Subject: Duke Energy Carolinas, LLC
William States Lee III Nuclear Station - Docket Nos. 52-018 and 52-019
AP1000 Combined License Application for the
William States Lee III Nuclear Station Units 1 and 2
Response to Request for Additional Information
(RAI No. 3621)
Ltr# WL12010.03-04

Lee Nuclear Station Response to Request for Additional Information (RAI)

Reference NRC RAI Number(s): RAI 02.05.02-049

**Figure 1. Lee Unit 1 Northwest Corner
Dynamic Profile Base Case Locations Used in Sensitivity Analysis**

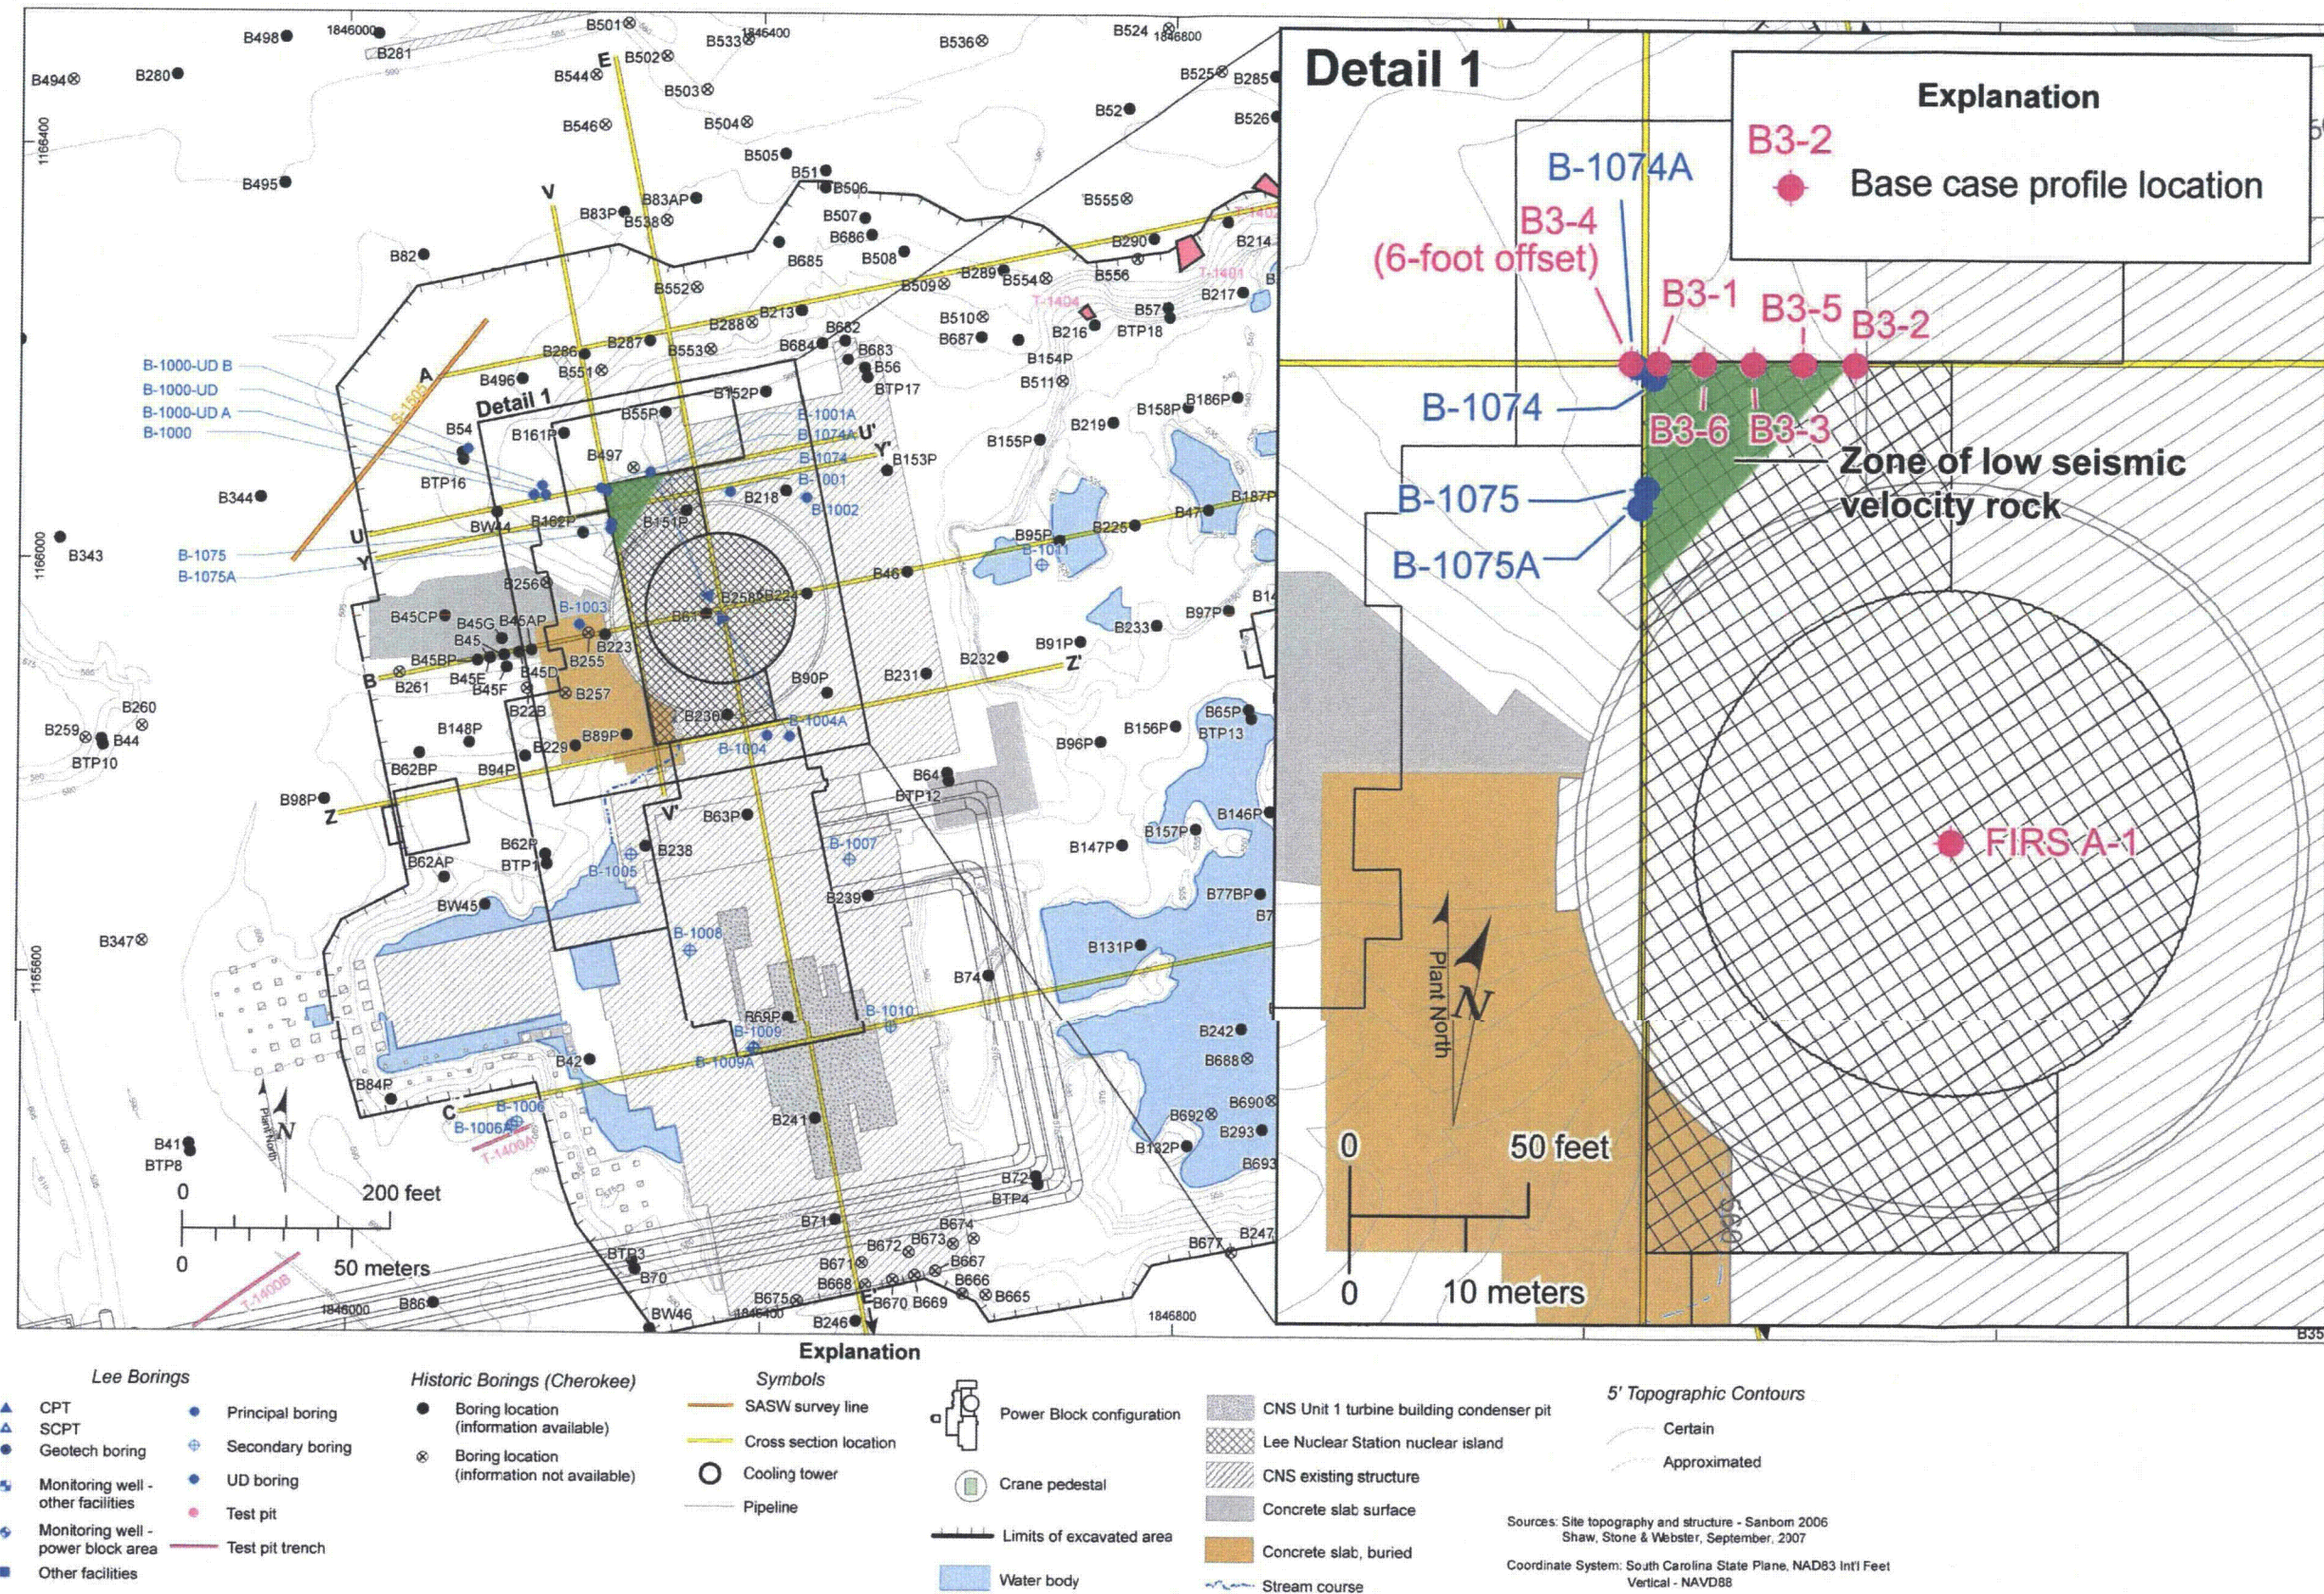
The response to RAIs 1292-4547 and 777-2507 indicated that since the volume of material under the northwest corner of the nuclear island is less than 3% of the total volume of the material beneath the Lee Unit 1, it does not require additional site response calculations. However, the staff is concerned about potential, localized, high-frequency amplification at the northwest corner. The staff performed initial confirmatory site response analysis using a modified subsurface profile B that included 21 ft of concrete replacing the upper part of the subsurface material for the northwest corner of the nuclear island. The staff's analysis found that between the frequencies of 20 and 30 Hz, the Foundation Input Response Spectrum (FIRS) at the northwest corner is about 20% higher than the WEC generic hard rock spectrum. Please comment on the significance of this high frequency exceedance.

As illustrated in Figure 1 (green-shaded area), the plan view dimensions of the northwest corner are 56 ft in the east-west direction (cross section line U-U', FSAR Figure 2.5.4-245) and 61 ft in the north-south direction (along cross section line V-V', FSAR Figure 2.5.4-246). This triangular shape approximates an isosceles triangle; in consideration of this negligible difference in shape the site response sensitivity results would be similar in either direction. Therefore, the sensitivity analysis is conducted in the east-west direction.

It is important to point out that the northwest corner wedge in its entirety underlies a maximum horizontal extent of about 61 ft of the nuclear island in the plant north-south and east-west directions and about only 41 ft diagonally (Figure 1). As Figure 2 and Figure 3 illustrate, the thickness of the material with shear-wave velocities of 5,348 ft/sec, less than that of the overlying fill concrete, has a maximum thickness of about 20 ft. The remainder of the wedge material which underlies the lowest velocity rock consists of a layer of relatively uniform thickness of about 10 ft with a shear-wave velocity of 7,575 ft/sec, near that of the fill concrete. Underlying that material is hard rock with a shear-wave velocity of 8,645 ft/sec, approaching that of the underlying reference hard rock at approximately 9,300 ft/sec (EPRI, 2004; FSAR Figure 2.5.4-249).
